April 11, 2017

FROM: David L. Rudland, Branch Chief */RA/*
Vessels & Internals Integrity Branch
Division of Engineering
Office of Nuclear Reactor Regulation

SUBJECT: CLOSURE MEMORANDUM SUPPORTING THE LIMITED
REVISION OF NUREG-0800 BRANCH TECHNICAL POSITION
5-3, "FRACTURE TOUGHNESS REQUIREMENTS"

Figure 1 Data analysis results from Figure 10-4 of TLR-RES/DE/CIB-2014-011

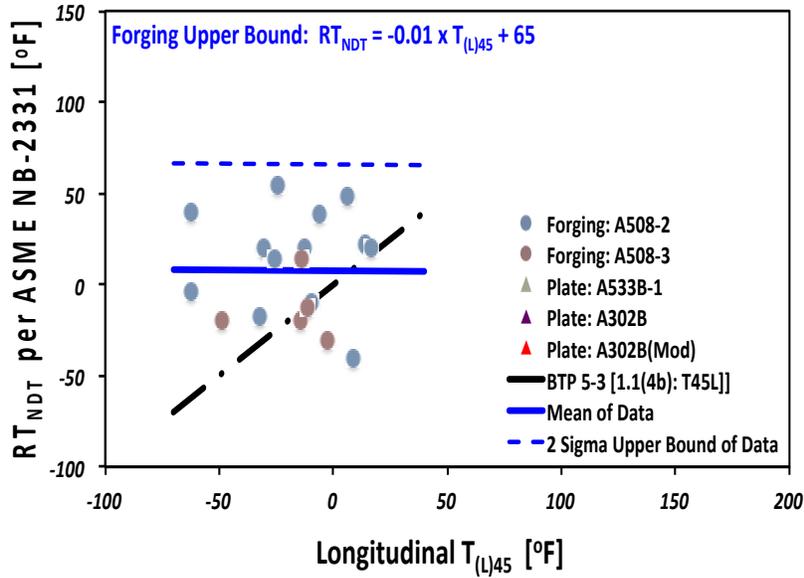
A plot of the data analysis based on the NRC TLR and the plot of the current analysis summarized in Table 1 are presented below for comparison. Figure 1 is a reproduction of Figure 10-4 from the NRC TLR. Figure 2 is a plot of the same data following Position B1.1(4) faithfully. Figure 2 indicates that many data points that were predicted by the NRC TLR approach in Figure 1 to be non-conservative (i.e., above the BTP 5-3 line) are now conservative based on the current approach. This supports the NRC staff's conclusion that the NRC TLR approach of using the Charpy curve over a range of test temperatures, instead of using the Charpy data at a single test temperature as required by Position B1.1(4), is overly conservative.

For plates, Figure 10-4 of the NRC TLR shows that the Position B1.1(4) line is bounding except for two data, which nevertheless are very close to the bounding line. Considering the above finding that the NRC TLR approach regarding Position B1.1(4) is overly conservative, the NRC staff has no doubt that Position B1.1(4) would bound all plate data if the same approach that was employed to produce Figure 2 results for forgings is employed for plates.

Figure 2 Current data analysis results from Table 1

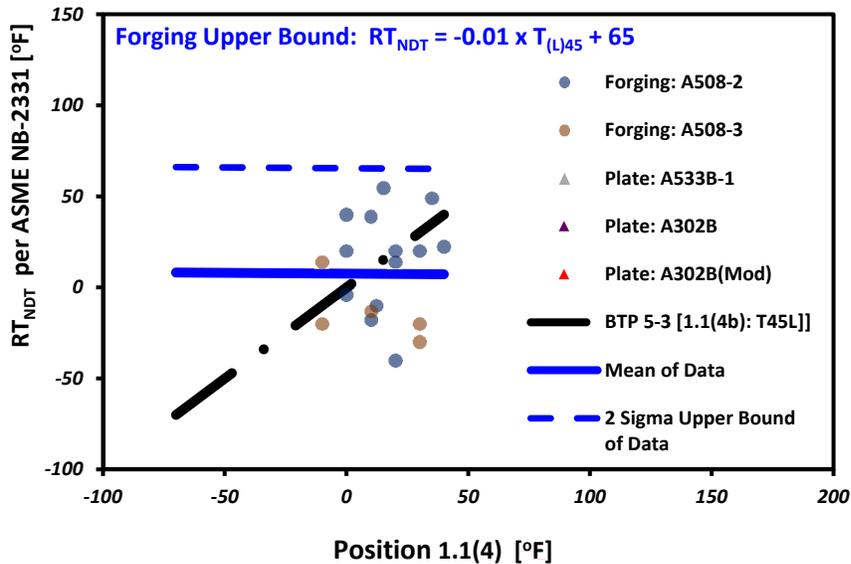
Based on the Table 1 results from the data analysis by NRC using the REAP database for forgings, the NRC staff determined that continued use of Position B1.1(4) to determine the mean initial RT_{NDT} values for plates and forgings is adequate. However, since Table 1 indicates that using a 2σ value of approximately 33.4 °C (60 °F) will bound all error (in the last column of Table 1) associated with using Position B1.1(4) for forgings, and since Figure 10-4 indicates that if Position B1.1(4) is followed faithfully, all plate data will be bounded, the staff concludes that for any applications using this position, an acceptable approach is to use a σ_1 of 0 °F for plates and a σ_1 of 30 °F for forgings. These σ_1 values are combined with σ_Δ in accordance with RG 1.99, Revision 2 to calculate the margin in estimating the ART for irradiated materials.
